I-25/Arapahoe Interchange

I-25/Arapahoe Interchange Finding of No Significant Impact

December 2012

**I-25/Arapahoe Road Interchange NEPA Study
Finding of No Significant Impact**

Figure 3. Existing and Action Alternative Cross Section - Looking East

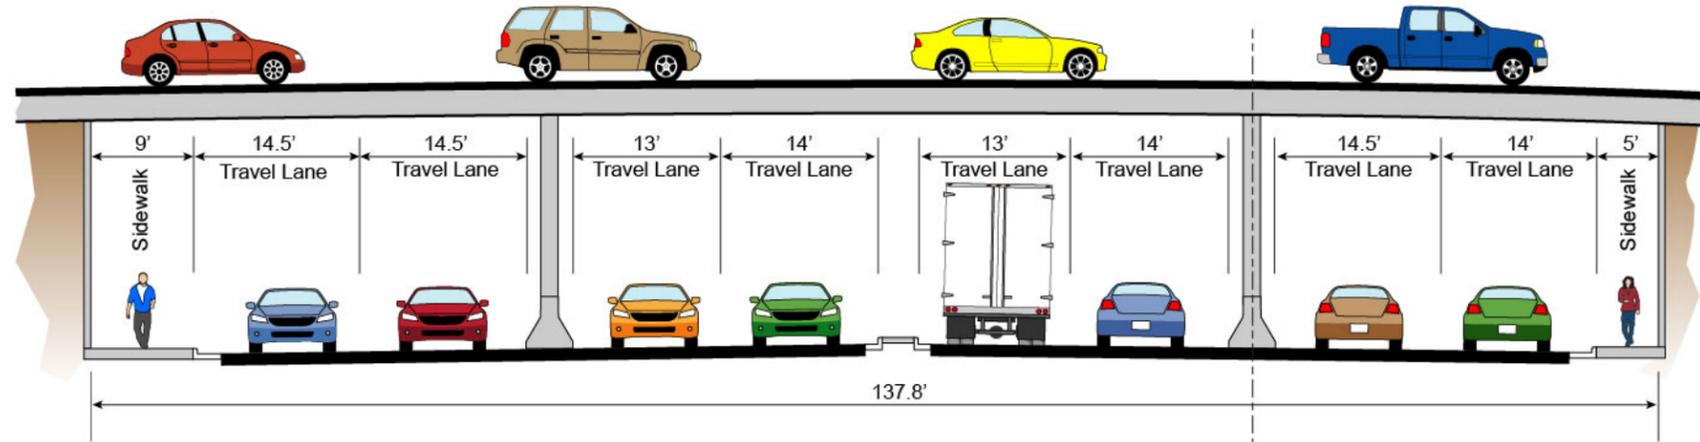
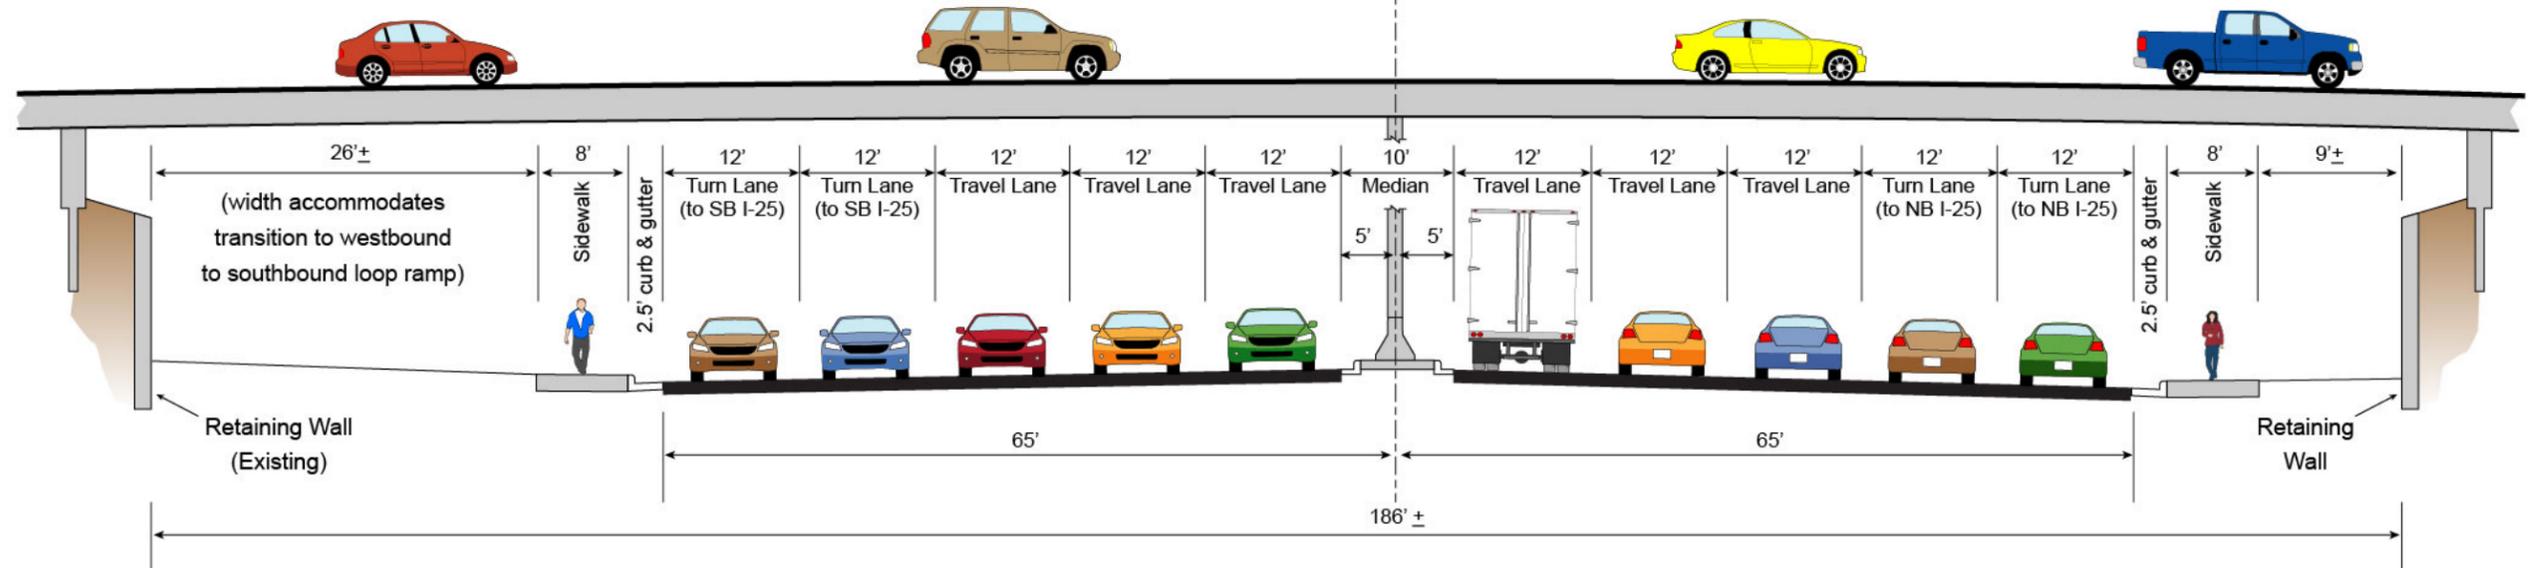
In looking at the alternatives and a couple of typical sections please make every effort to provide better pedestrian accommodations through the interchange area. The typical sections as they stand are less than ideal. I am especially concerned with the areas that are only receiving 5' sidewalks. It appears that there will be areas that will have a 5' sidewalk immediately adjacent to Arapahoe Road with a retaining wall and/or sound wall at the edge of sidewalk. With cars traveling 40-50 miles per hour on Arapahoe the 2' of sidewalk closest to the road is in essence unusable and with the wall immediately adjacent it's impossible to walk within 1.5' of the wall without chopping off an arm and shoulder so the project has in essence designed a 1' foot path of usable sidewalk. There are also cyclists that use this sidewalk to get to their destinations. Arapahoe Road is less than ideal for a cyclist but many times it is the most direct route.

Response to W-4. The project improves sidewalks to as great an extent as possible without taking adjacent residential property, which was determined to be a critical issue during alternatives development and conceptual design. Existing sidewalks would be reconstructed along both the north and south sides of Arapahoe Road from west of Yosemite Street, through the interchange, to east of Boston/Clinton Street. Sidewalk widths would vary from 8 to 10 feet in the project area. All attempts will be made to maximize sidewalk width and construct detached sidewalks where reasonable within available ROW. However, 5-foot sidewalk segments may be utilized along Arapahoe Road west of Yosemite Street and along Yosemite Street south of Arapahoe Road where a commitment was made to avoid residential property acquisition. Maximizing sidewalk width within the available ROW will be considered again during final design.
